UNITED STATES PATENT AND TRADEMARK OFFICE

APPLICATION NO.	FILING DATE	FIRST NAMED INVENTOR	ATTORNEY DOCKET NO.	CONFIRMATION NO.
09/869,637	01/15/2002	Richard Peter Glover	302/1/013	5754

Office Action Summary

DETAILED ACTION

FIG. 1

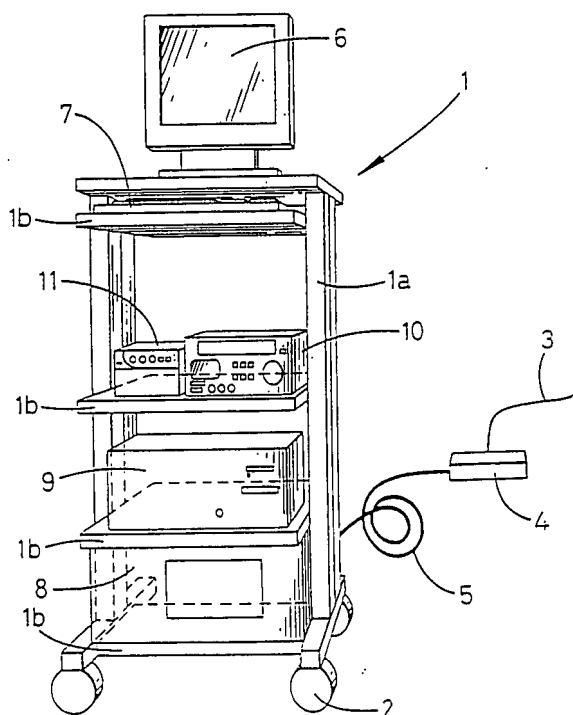
1. The corrected or substitute drawing was received on 01/15/02 in regard to Fig. 3. The examiner approves this drawing change.
2. Figure 1 should be designated by a legend such as --Prior Art-- because only that which is old is illustrated. See MPEP § 608.02(g). A proposed drawing correction or corrected drawings are required in reply to the Office action to avoid abandonment of the application. The objection to the drawings will not be held in abeyance.

In regard to claim 1, AAPA teaches an IVUS system (1) comprising: a catheter (3) obviously having an ultrasonic transducer array mounted at least near a distal end thereof; a catheter interface module (4) connected to a proximal end of the catheter; a display monitor (6); a control device (7) for controlling the system; and a signal processing data entry and data storage device (9) for processing and storing data derived from energization of the ultrasonic transducer array to output a signal to the display monitor (12) in order to display an image of an interior of a patient's body (page 3, line 20 - page 4, line 10; also see Fig. 1 below).

The IVUS systems are used with patients usually lying on a bed so that the addition feature of the bed is also obviously present in the system. According to the prior art Fig. 1, the catheter interface module, the display monitor and the control device are adapted to be located adjacent to the bed. It would have been obvious to an ordinary skill in the art, at the time the invention was made to adequately position the signal processing data entry and data storage device remotely from the bed at a sufficient distance to enable a clear space around the bed.

In regard to claim 2, it would have been obvious to an ordinary skill in the art, at the time the invention was made to know that the power distribution unit (8), the video recorder (10) and the video printer (11) as disclosed by AAPA (see Fig. 1) are also adapted to be located remotely from the bed.

In regard to claim 3, the display monitor disclosed in AAPA (see Fig. 1 above) comprises a flat screen monitor.

In regard to claim 4, AAPA teaches all the limitations of the claimed subject matter (see Fig. 1 above) except for mentioning specifically that the control device incorporates a device to enable control instructions to be given by voice and that it incorporates a voice recognition device for accepting and implementing those instructions.

In regard to claim 7, AAPA teaches all the limitations of the claimed subject matter (see Fig. 1 above) except for mentioning specifically that the control device includes an infra-red remote control device.
